AVIONS PIERRE ROBIN

SERVICE BULLETIN N° : 51

OBJECT : Modification of blanking plates, on rear fuselage sides.

AIRCRAFT CONCERNED : HR 200/100 and HR 200/120, up to n° 26 inclusive,  
except n° : 20, 23, 24 and 25.

Blanking plate

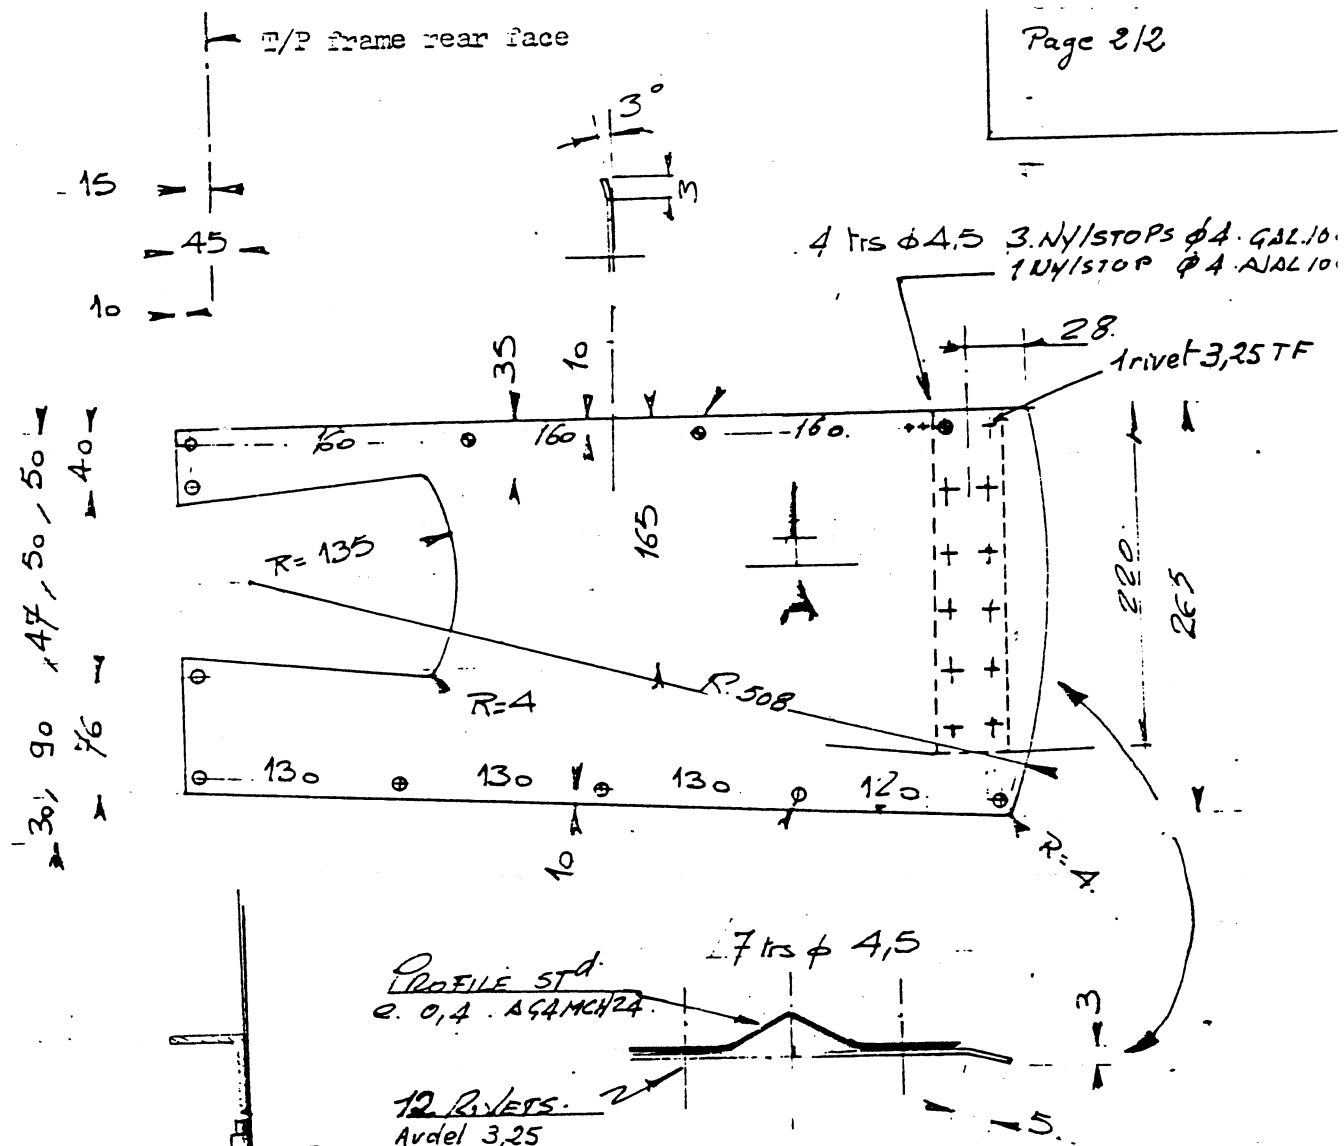
Upon receipt of this Service Bulletin, check to see if the fork-end fitting of the elevator tab control comes into contact with the end of the rear fuselage blanking plate, or if the said end of the plate is distorted. If this is the case, embody Modification n° 1166 (see drawing, page 2/2) as soon as possible. A ferrying flight can be carried out, after having straightened the plate rear end so as to prevent it from contacting the fork-end fitting.

In any case, Modification n° 1166 (which consists in rivetting a stiffener on the inside face of the plate, and in reducing the length of the latter) must be embodied, at the latest, within the next 20 flying hours and, in any case, before June 30th 1974.

① LH side plate (drawing)

② RH side plate (symmetrical)

Mat: AG4 MCH24 ép: 0,5.
